**SECTION 00 9111
ADDENDUM NUMBER ONE**

DATE: JULY 28, 2025

PROJECT: IOWA STATE FAIR – SWINE-CATTLE BARN UPDATES – PHASE 1

ARCHITECT: KEFFER/OVERTON ARCHITECTS

P102-2

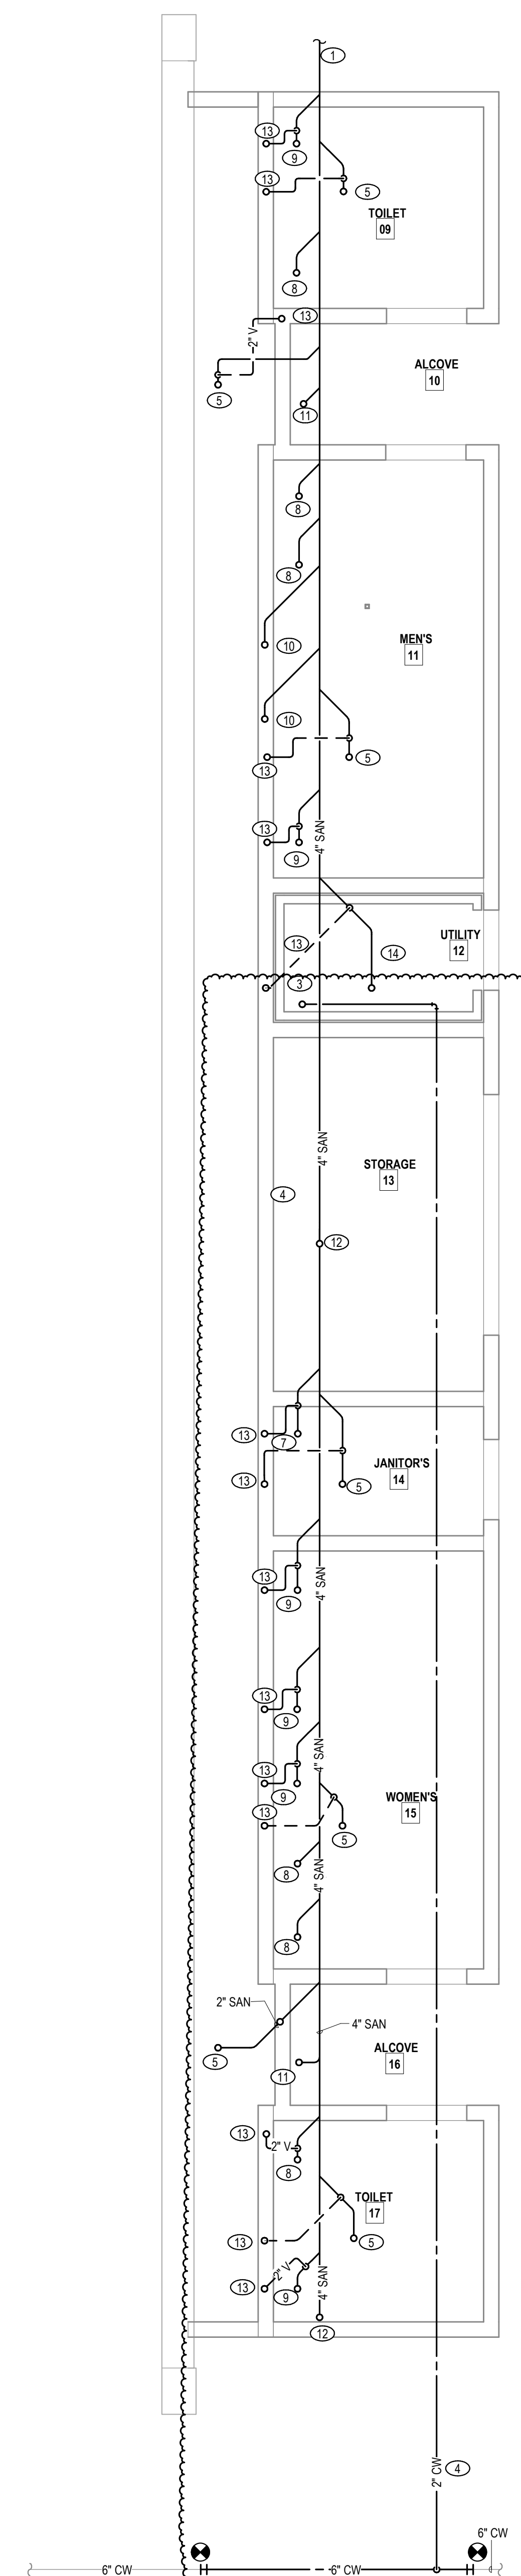
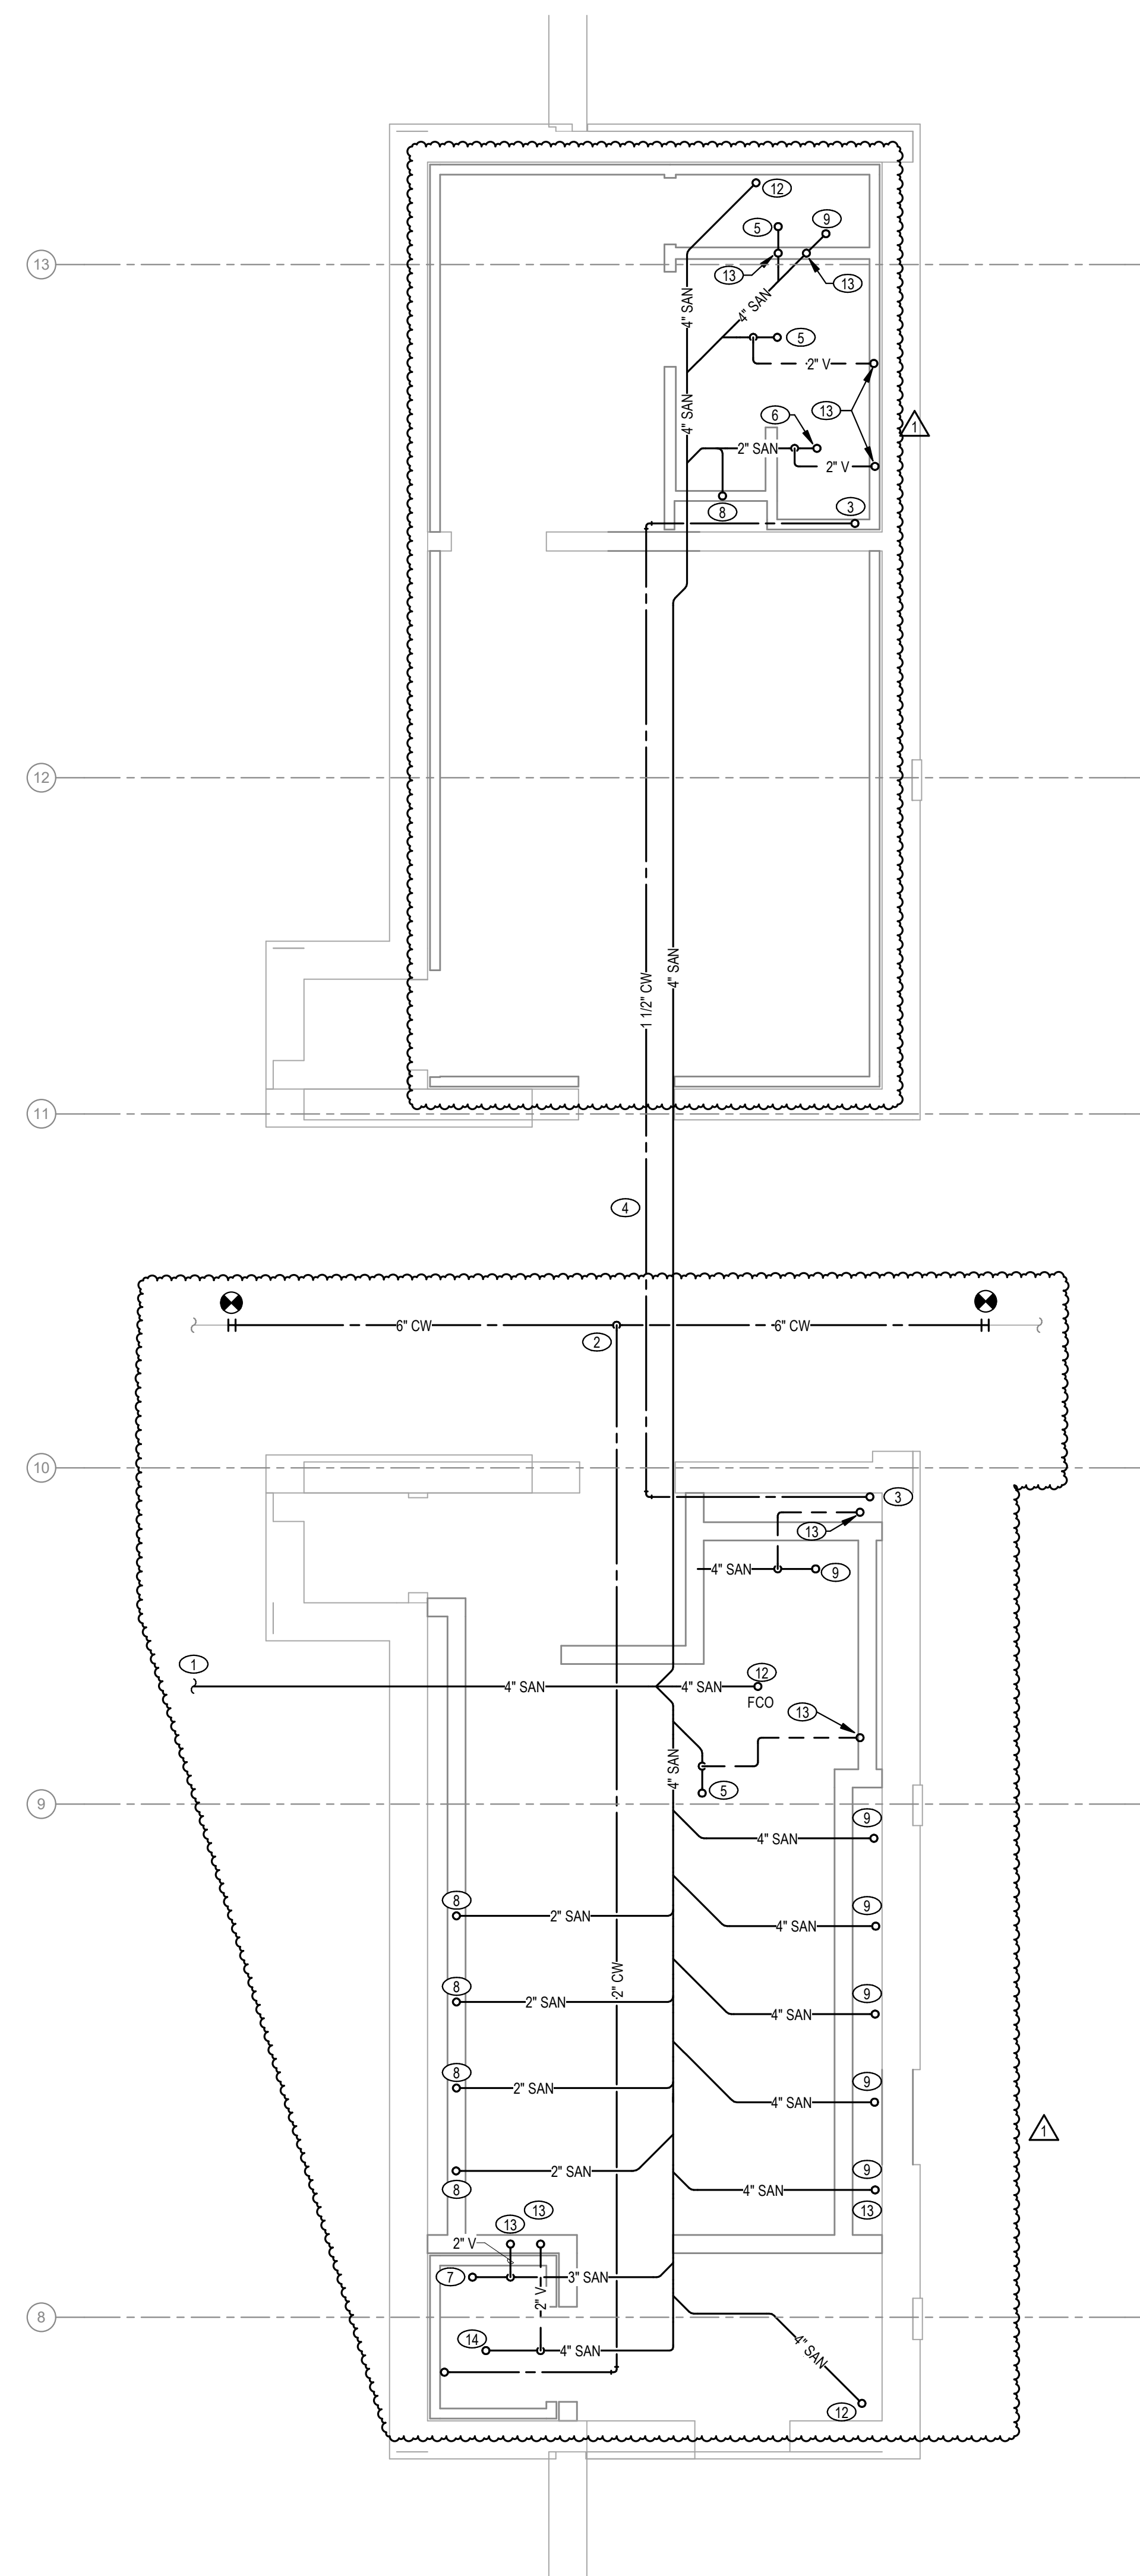
- A. SHEET P102-1 – PLUMBING UNDERFLOOR ENLARGED PLANS (Refer to revised sheet.)
1. REVISE routing of sanitary lines and cold water line in Office / Women's Group A area.
 2. ADD portion of existing 6" cold water main as being replaced with new.
 3. ADD keyed note #15
- B. SHEET P102-2 – PLUMBING ENLARGED PLANS (Refer to revised sheet.)
1. REVISE plumbing pipe routing above floor in Office / Women's Group A area.
 2. REVISE plumbing pipe routing to lavatories in Restroom Group D area.
 3. ADD keyed notes #12, #13, & #14.
 4. REVISE location of exterior hose bibb HB-1 in Restroom Group D area.

MECHANICAL ENLARGED
PLANS

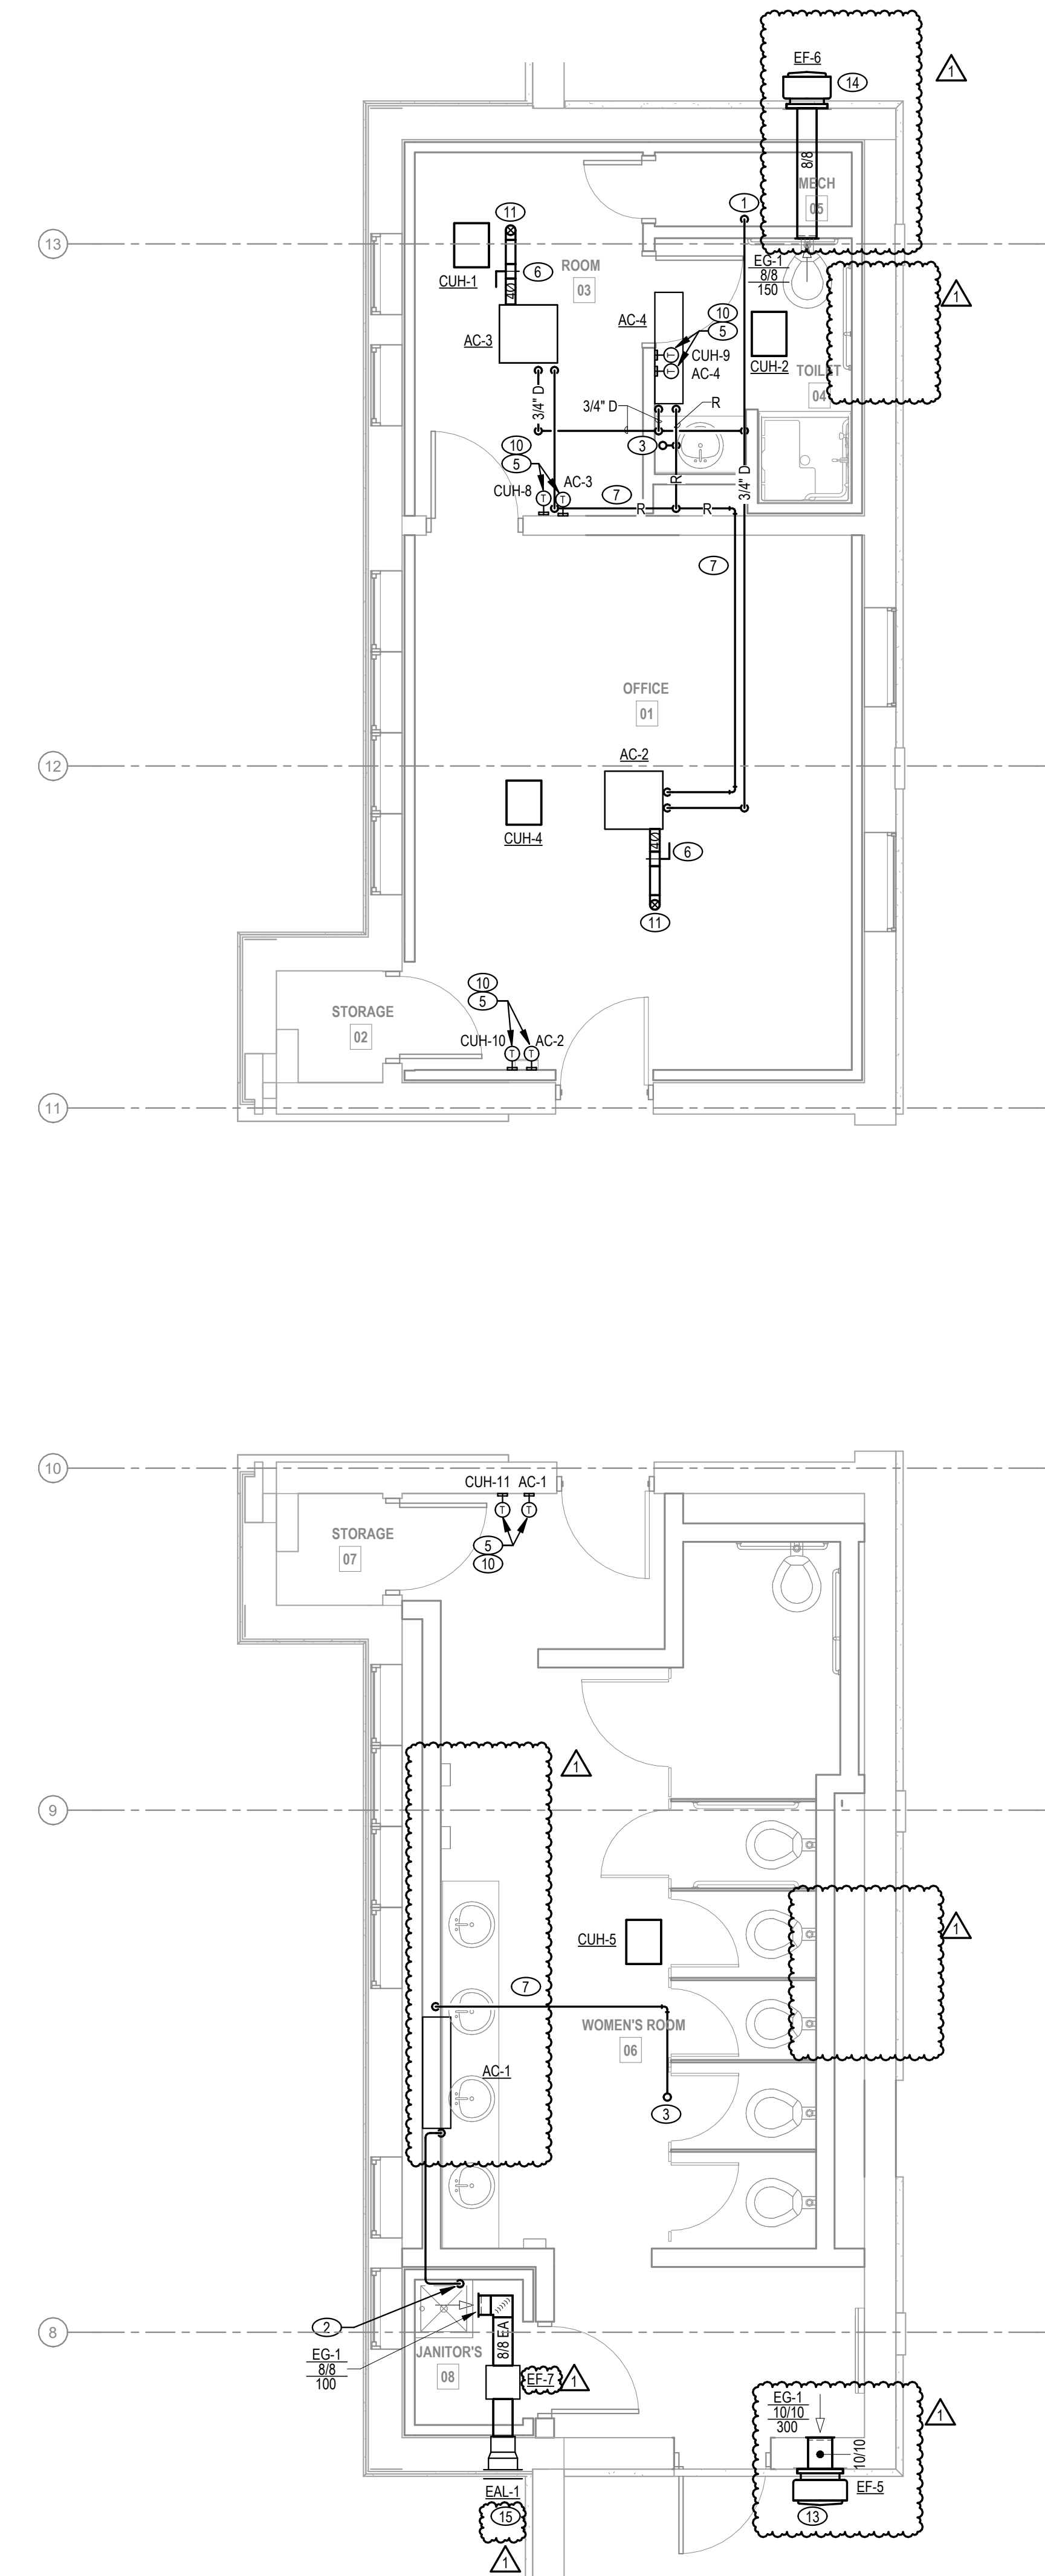
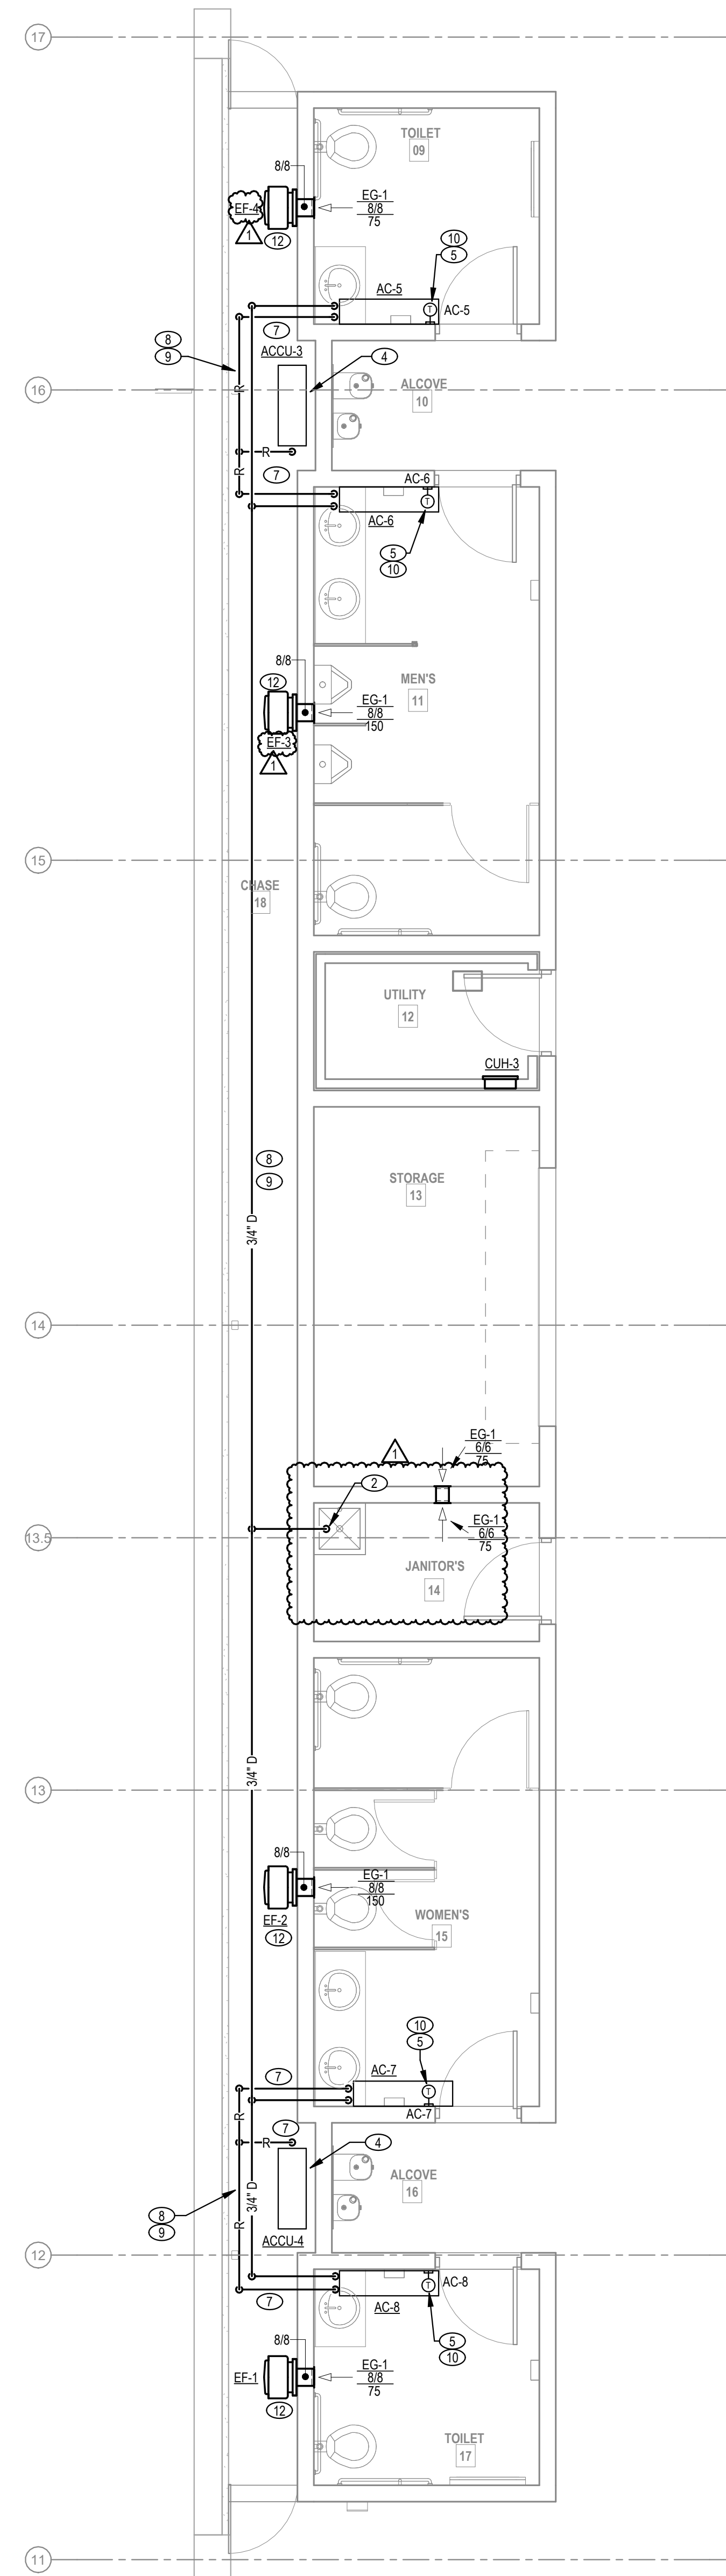
- A. SHEET M102-1 – MECHANICAL ENLARGED PLANS (Refer to revised sheet.)
1. DELETE EF-3.
 2. REVISE fan labels for fans EF-4 through EF-8 (See updated schedule on M500).
 3. REVISE location of EF-5.
 4. REVISE location of EF-6.
 5. REVISE location of AC-1.
- B. SHEET M500 – MECHANICAL DETAILS & SCHEDULES (Refer to revised sheet.)
1. DELETE fan EF-3.
 2. REVISE fan labels for EF-4 through EF-8 to now be labeled EF-3 through EF-7.P
